PROPOSAL, CONTRACT, BOND AND SPECIFICATIONS

E Main Street and South Hancock Street Assessment District - 2025

CONTRACT NO. 8784

1. REVISED SHEETS: D-1, D-2, D-6, D-7, INT-2, INT-3, INT-7, P-1, P-2, P-4, P-6, U-1 - U-7, U-12, W-1, W-2, W-5 - W-7, E-1 - E-9, PM-8, X-15, AND X-16.

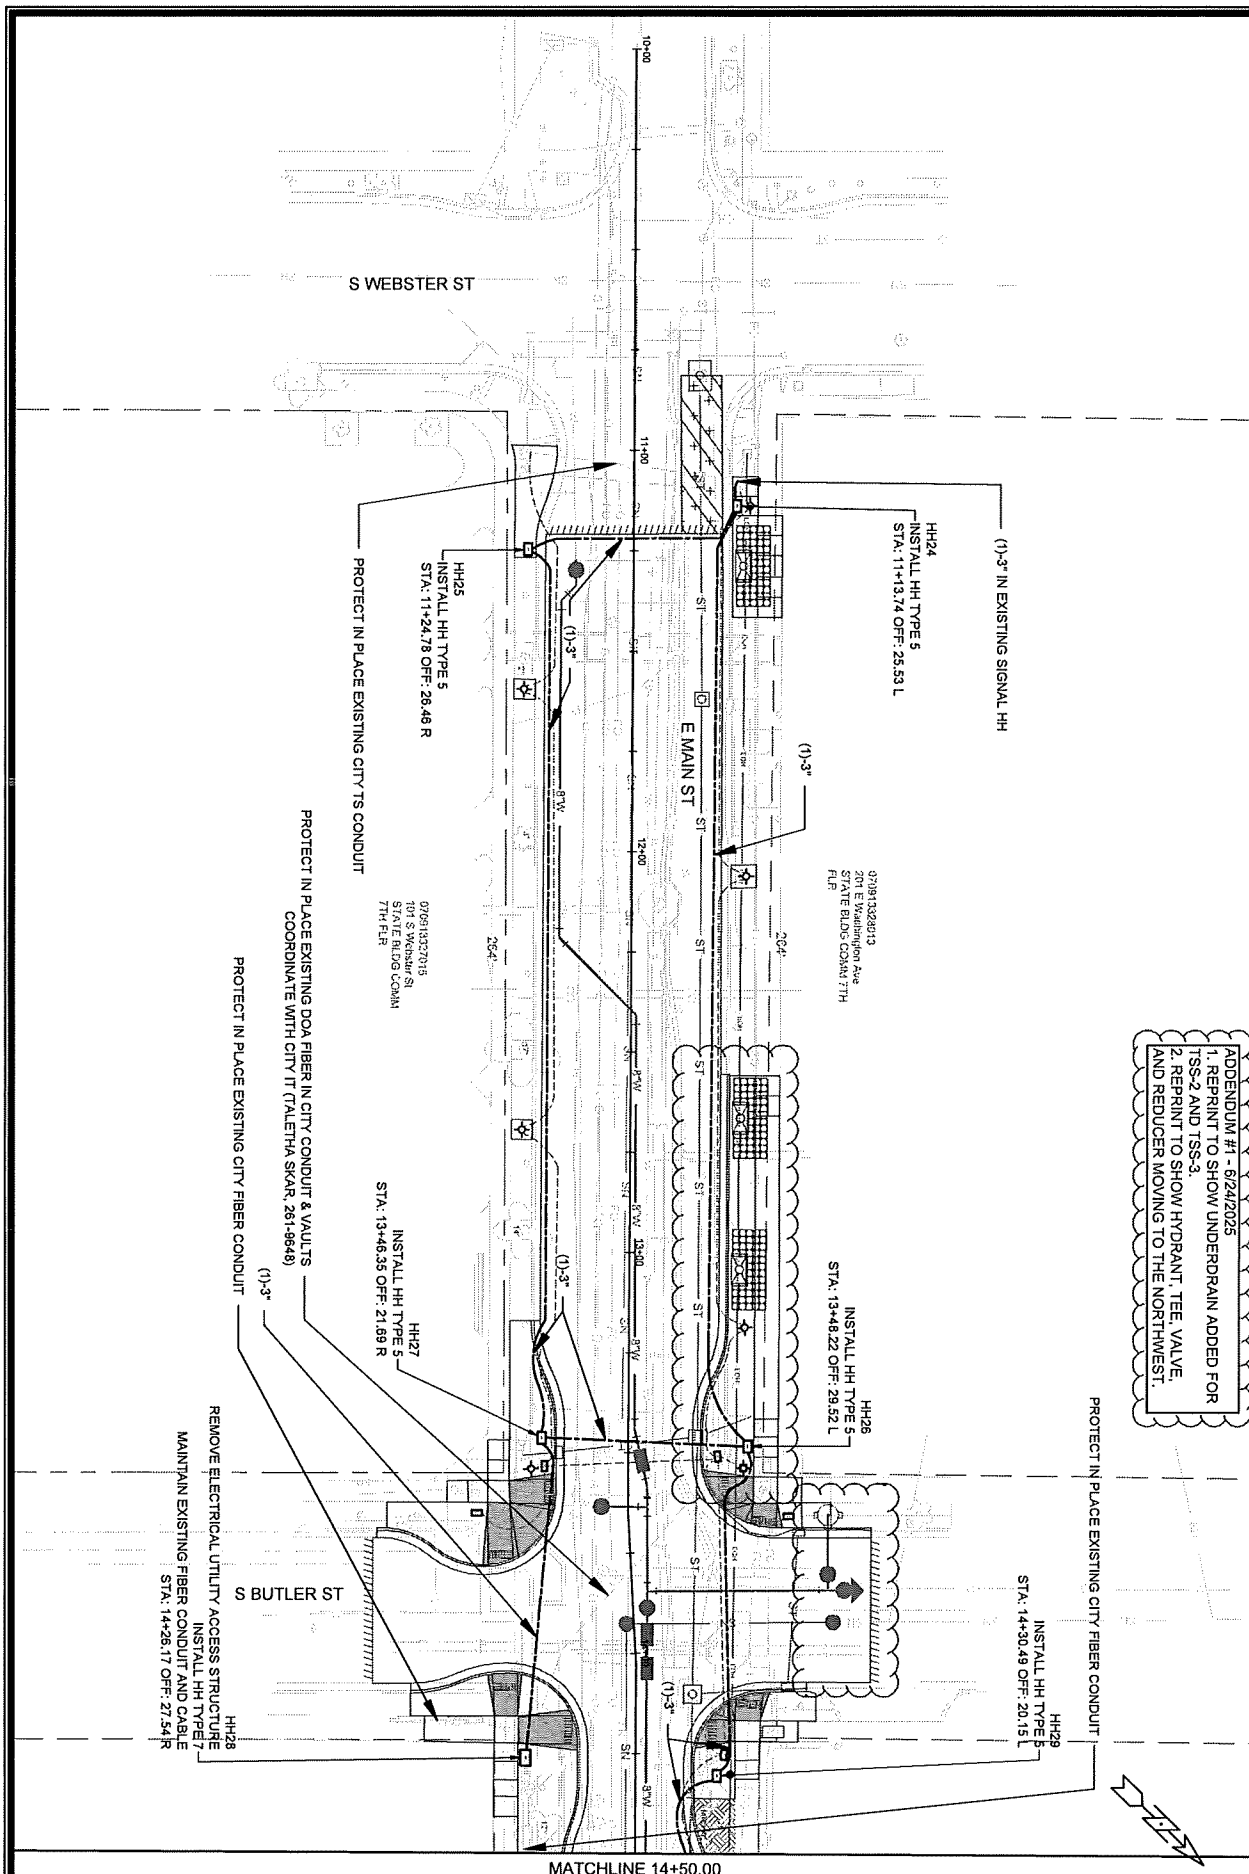
ADDENDUM #1 - 6/24/2025
REPRINT TO REFLECT CHANGES TO CURB
REMOVAL/REPLACEMENT ON S. HANCOCK
STREET SOUTH OF E. WILSON STREET.

ADDENDUM #1 - 6/24/2025
 1. REPRINT TO SHOW UNDERDRAIN ADDED FOR ISS-2 AND ISS-3.
 2. REPRINT TO SHOW HYDRANT, TEE, VALVE, AND REDUCER MOVING TO THE NORTHWEST.

ELECTRICAL PLAN - FIBER OPTIC		15125
	E. MAIN STREET & S. HANCOCK STREET ASSESSMENT DISTRICT - 2025		MADISON, WI
	M:\DESIGN\Projects\15125\CAD\Traffic\15125TE-Electrical.dwg		CONTRACT NO: 8784
15125	15125	15125	15125

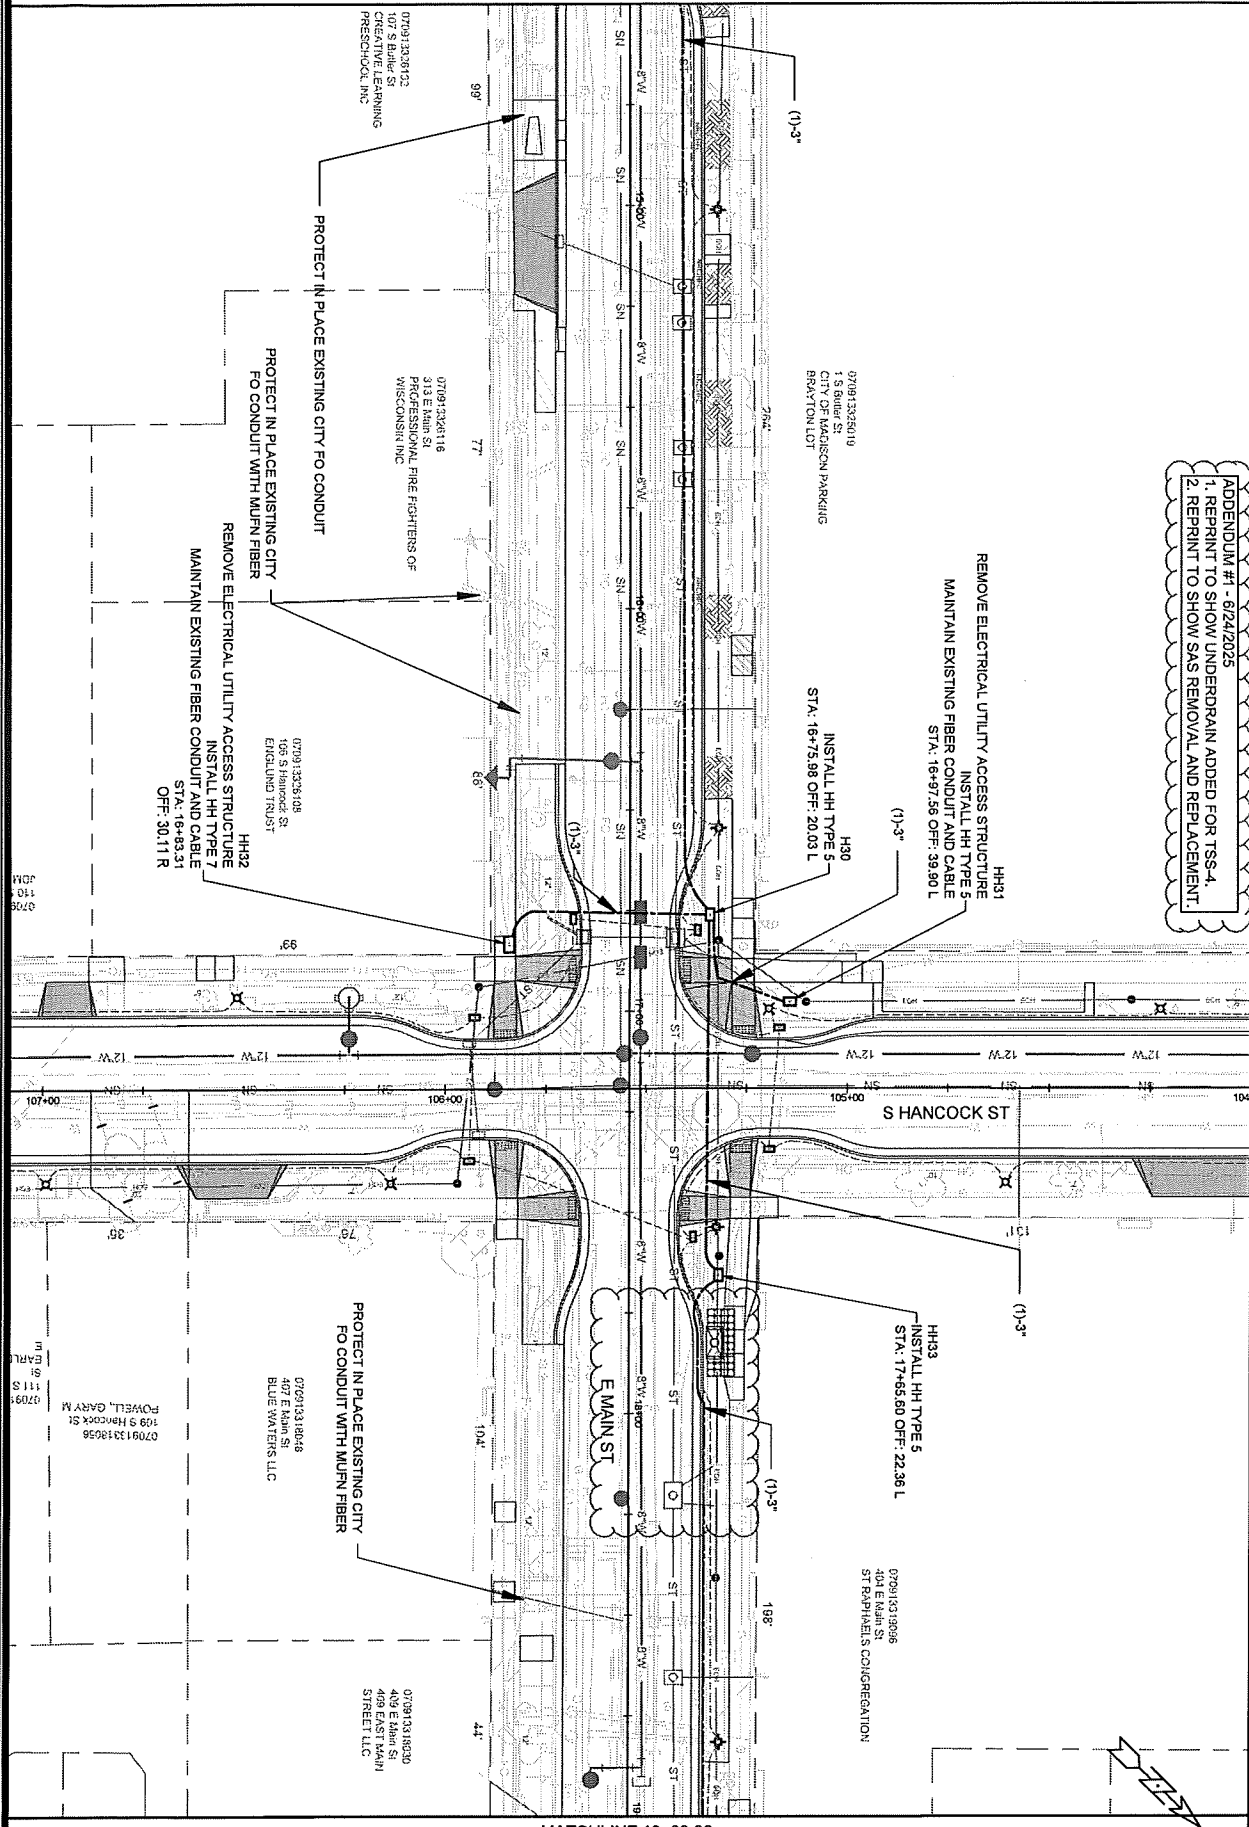
ADDENDUM #1 - 6/24/2025
1. REPRINT TO SHOW UNDERDRAIN ADDED FOR TSS-4.
2. REPRINT TO SHOW SAS REMOVAL AND REPLACEMENT.

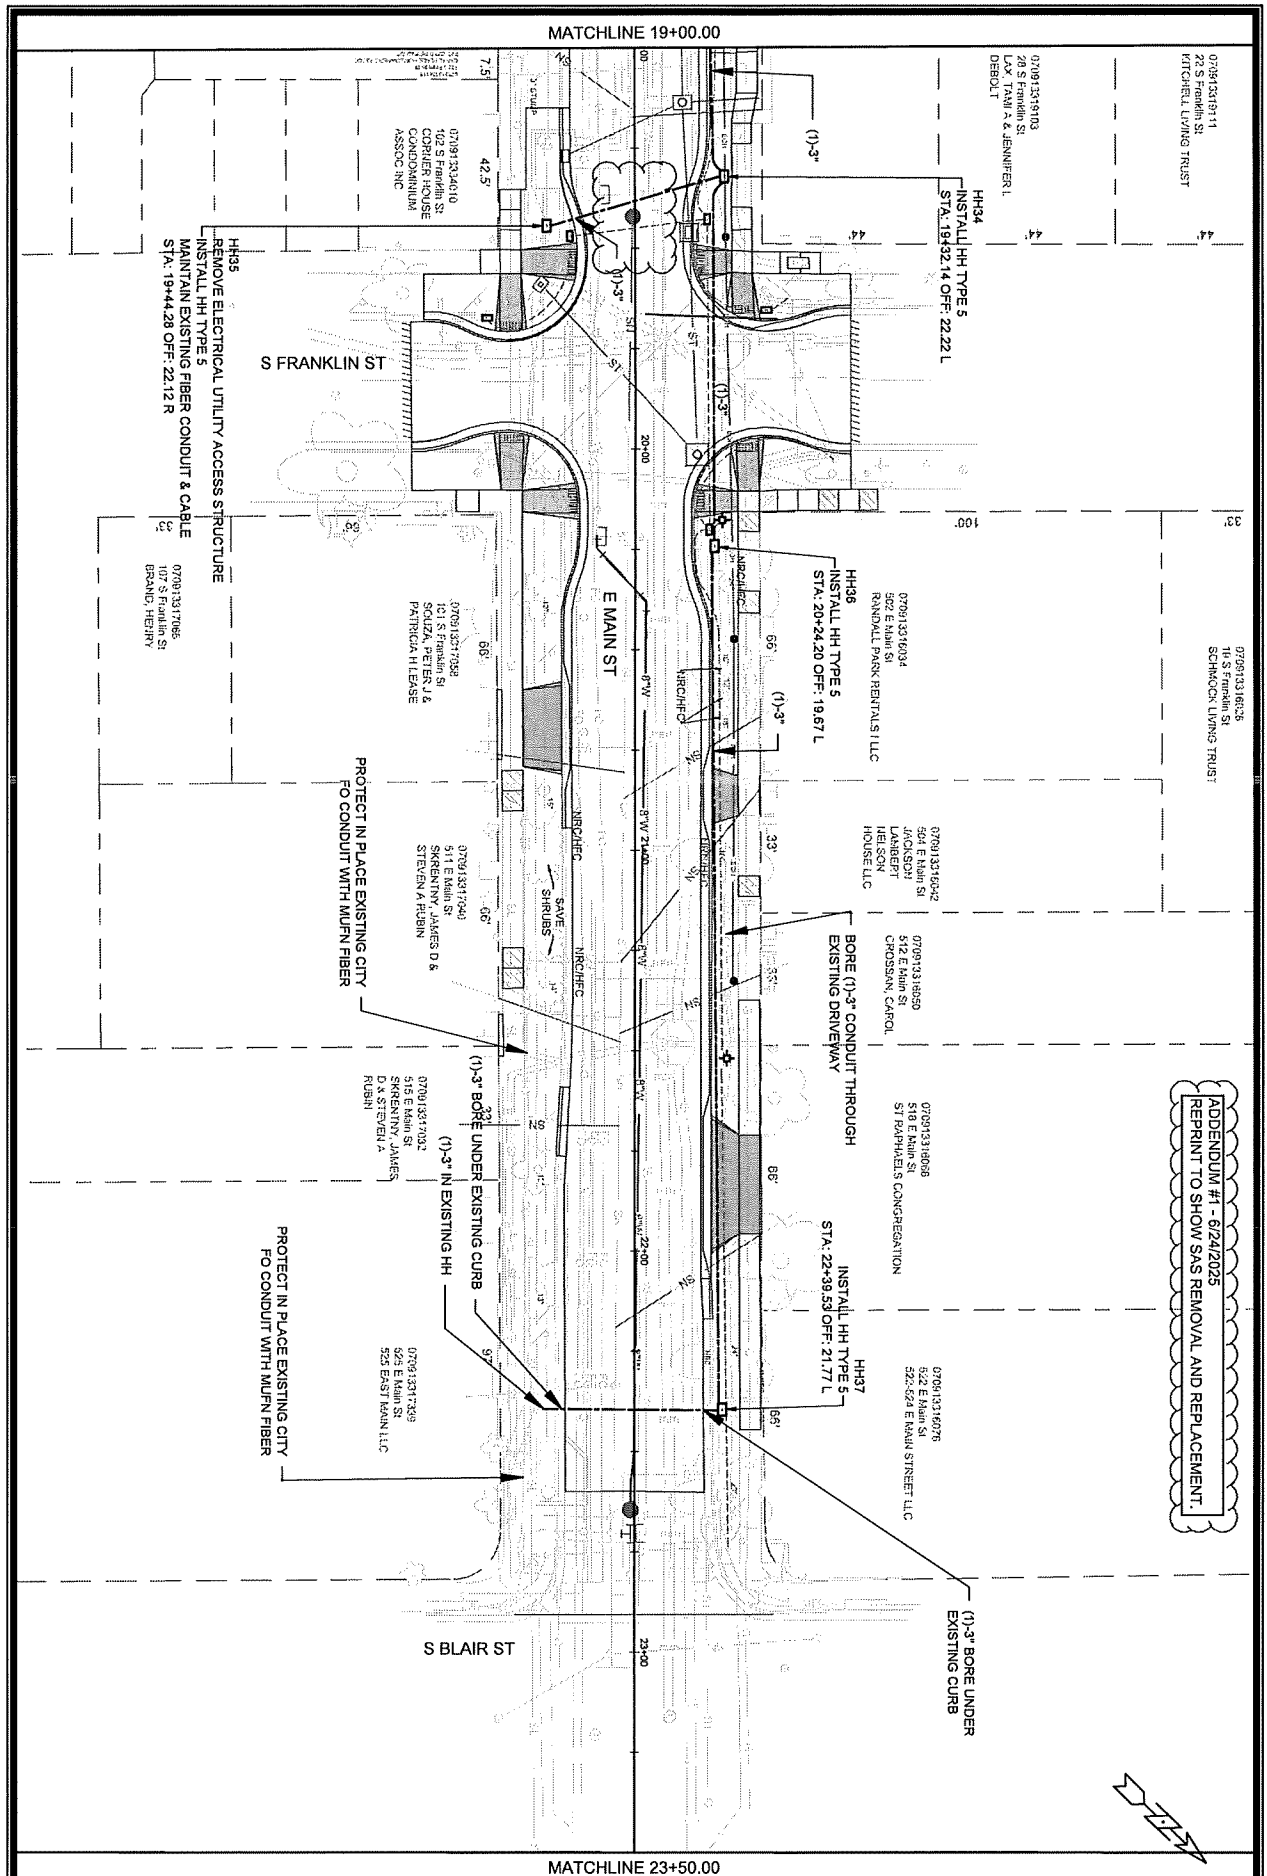
ADDENDUM #1 - 6/24/2025
 REPRINT TO SHOW SAS REMOVAL AND REPLACEMENT.

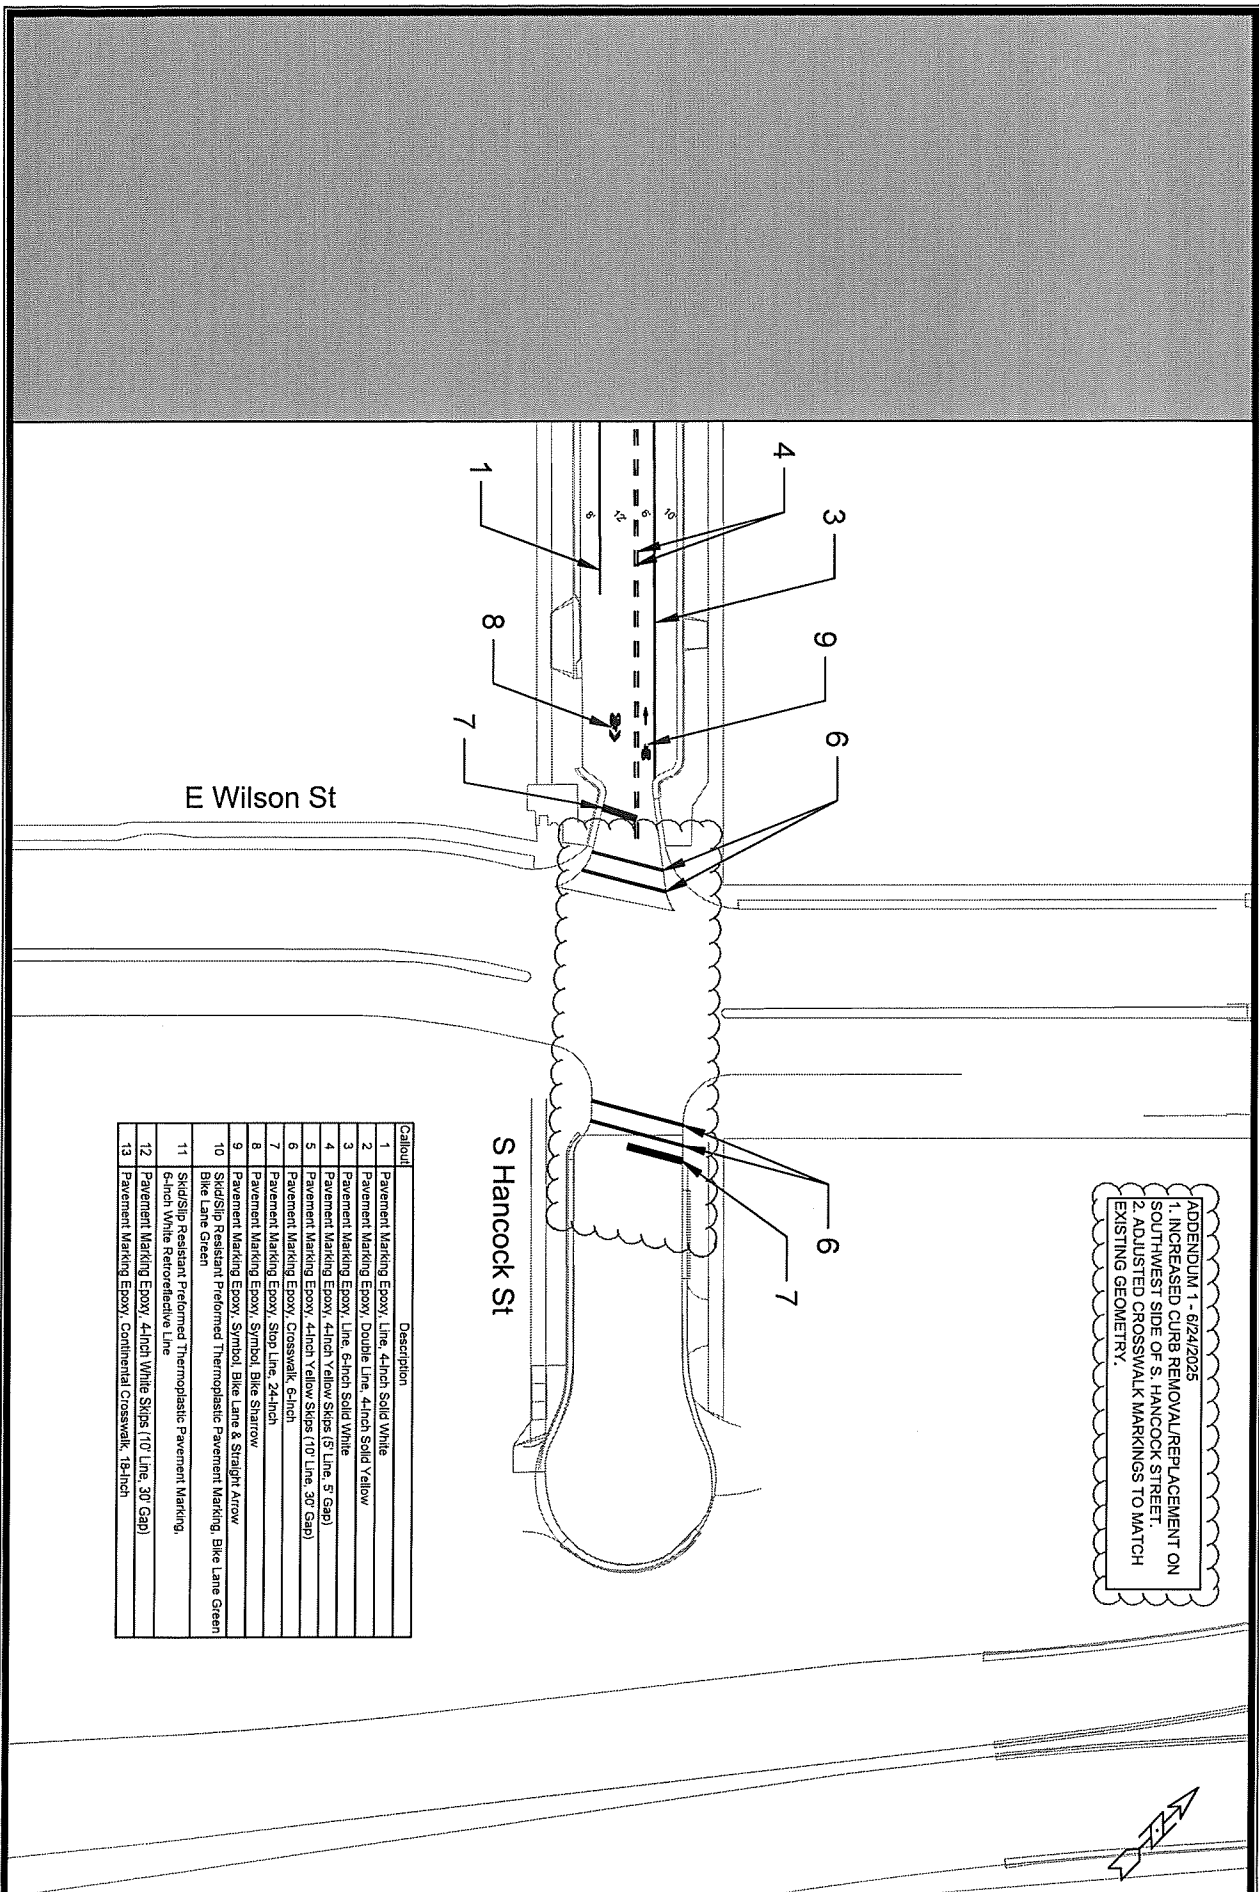
ADDENDUM 1 - 6/24/2025
 1. INCREASED CURB REMOVAL/REPLACEMENT ON
 SOUTHWEST SIDE OF S. HANCOCK STREET.
 2. ADJUSTED CROSSWALK MARKINGS TO MATCH
 EXISTING GEOMETRY.

112+75.00

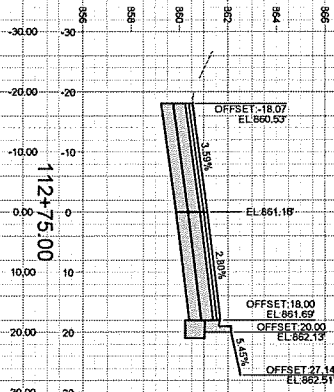
ADDENDUM #1 - 6/24/2025
 1. ADDED SECTION VIEW 112+75.
 2. REMOVED AND REPLACED CURB ON RIGHT SIDE.
